# **PINEHURST SUBDIVISION, RESUBDIVISION OF LOTS 7-12 OF THE RESUBDIVISION OF BLOCKS 14 AND 15**

APPLICATION NUMBER 17 DATE November 6, 2003

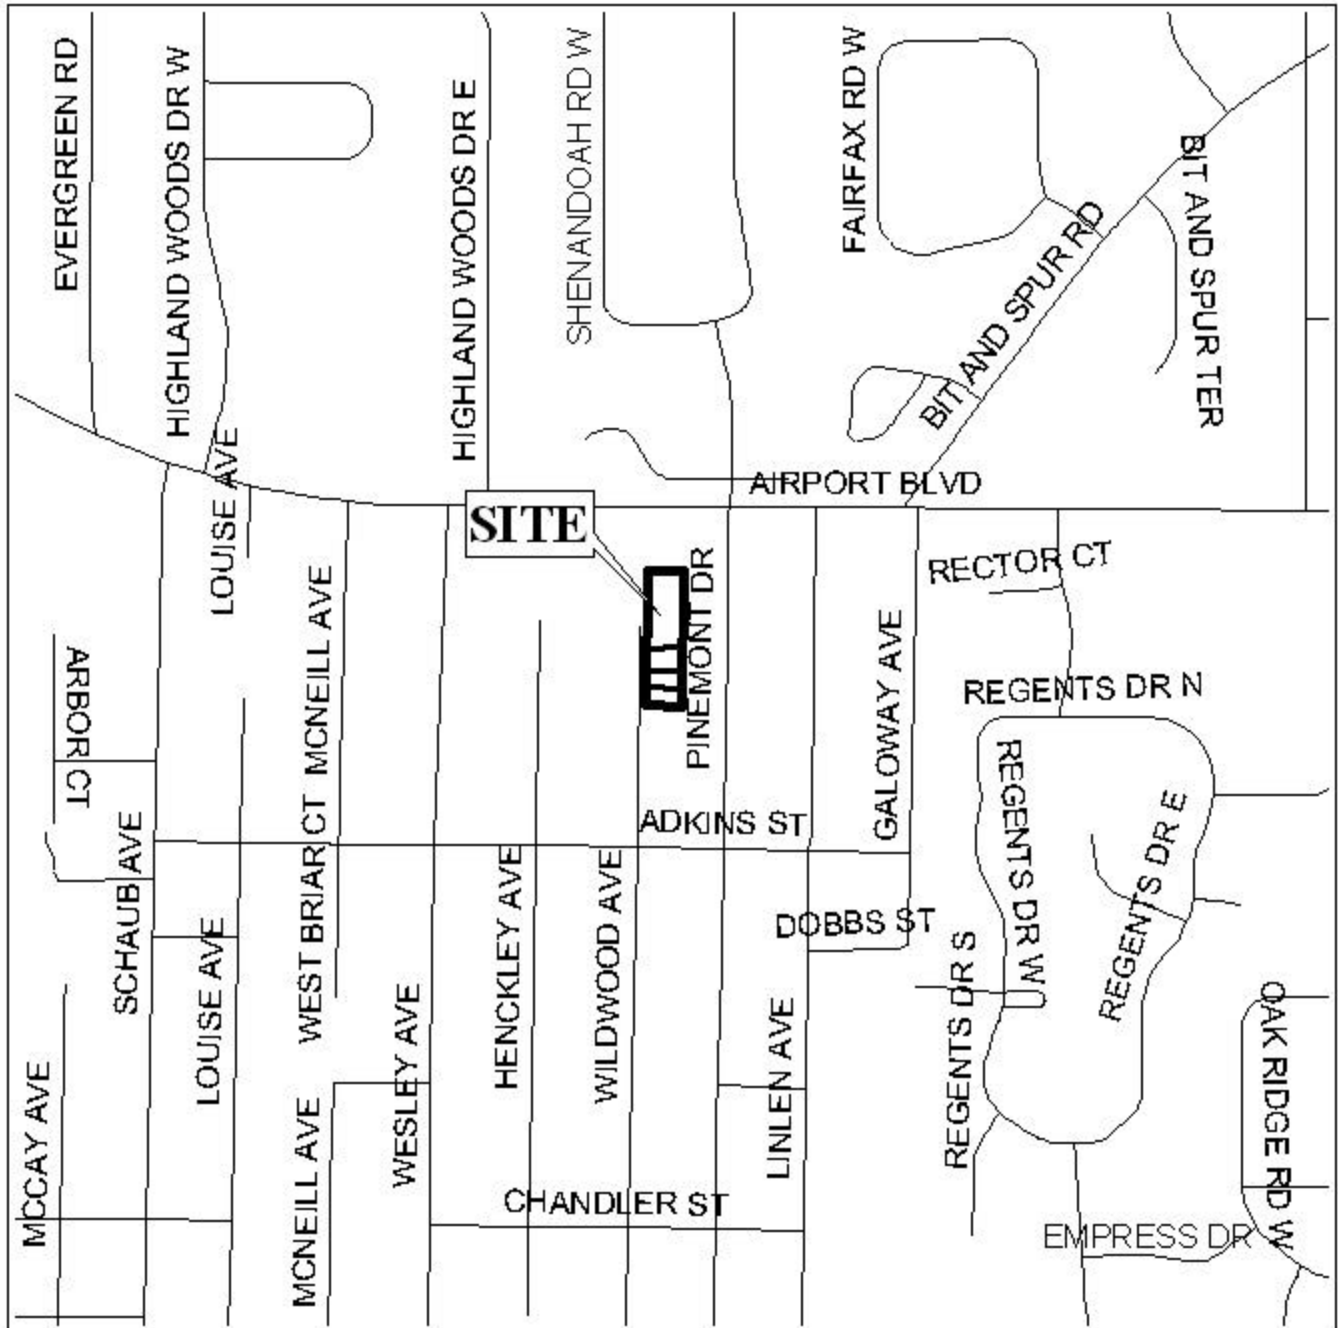
Engineering Comments: Must comply with all stormwater and flood control ordinances. Any work performed in the right-of-way will require a right-of-way permit.

Traffic Engineering Comments: Driveway numbers, size, location and design to be approved by Traffic Engineering and conform to AASHTO standards.

Wildwood Avenue, which has an existing right-of-way of 45-feet, is a minor street, and as such requires a 50-foot right-of-way; therefore, the dedication of sufficient right-of-way to provide 25 feet from the centerline should be required.

The plat meets the minimum requirements of the Subdivision Regulations and is recommended for Tentative Approval subject to the following conditions: 1) the placement of a note on the final plat stating that the dedication of sufficient right-of-way to provide 25 feet from the centerline of Wildwood Avenue; and 2) the placement of a note on the final plat stating that the size, number, location and design of curb cuts to Wildwood Avenue for Lot 4 must be approved by Traffic Engineering.
